**RE: ROYAL PRINCE ALFRED HOSPITAL STAFF CARPARK
106-112 CHURCH STREET, CAMPERDOWN
BUILDING CODE OF AUSTRALIA 2016 (BCA)
COMPLIANCE CAPABILITY STATEMENT**

ROYAL PRINCE ALFRED HOSPITAL – PROPOSED MULTISTORY CAR PARK PROVISION FOR FIRE ENGINEERING (FOR DA SUBMISSION)

Figure 1: Level 0 Plan (Ground Floor)

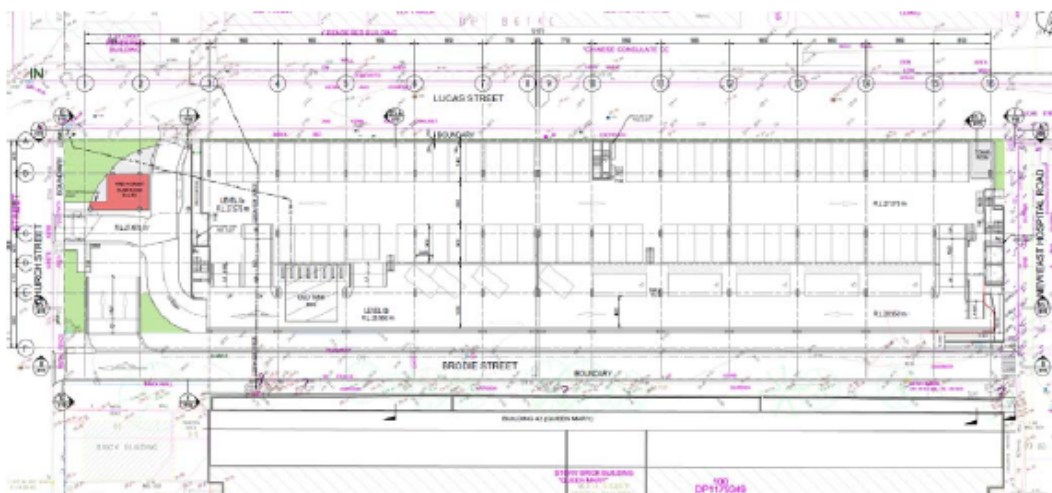
Egress from the car park is via 3 separate fire-isolated exits, which discharge directly to an open space on ground floor. Each level of the car park will comprise of split floors, with interconnecting stairways between these levels.

The car park will be designed as being open deck, and is therefore not required to be provided with fire sprinklers.
